From: Paul Porada <pporada@woodardcurran.com>
Sent: Friday, August 03, 2018 12:07 PM
To: Meidel, Susanne K
Cc: 'Bob Linkletter'; swipple@mainelyenvironmental.com; Celia Raymond
Subject: Reclassification proposal for East Branch Wesserunsett Stream
Attachments: 2018.07.05 memo extraction.pdf

**Maine Department of Environmental Protection
2018 List of Water Quality Standards Re-Classification Proposals**

Table 1 List of Proposals Received

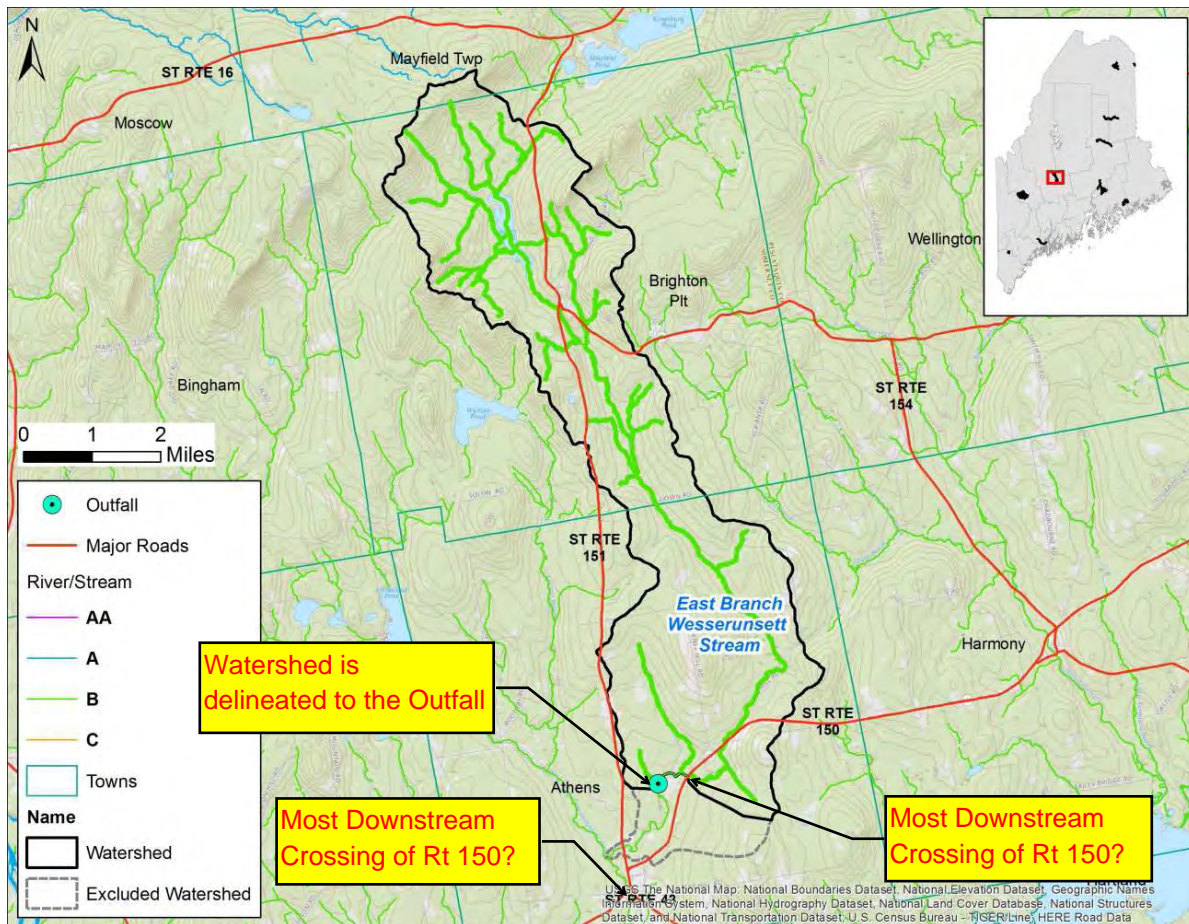
Consider the statement 'East Branch Wesserunsett Stream above the downstream Rt 150 crossing'. There may be ambiguity where the East Branch and the West Branch combine to form a main stem. Route 150 crosses Wesserunsett Stream three times. To demonstrate reflect on this question: Is Rt 150 crossed twice on the East Branch and once on the West Branch, or three crossings of the East Branch? Another combination exists too. Point here, the words "above the downstream Rt 150 crossing" could be replaced with "above the downstream Harmony Road crossing in Athens" to offer less uncertainty. This will rule out any misinterpretation that downstream Rt 150 is the South Main Street crossing.

The watershed delineation on the memo map appears to be taken to the outfall location. At the map scale it is difficult to tell if the stream is included or if the line was intended only to capture the watershed tributaries. I suspect the outfall is not in the Class A waters Watershed. Please confirm.
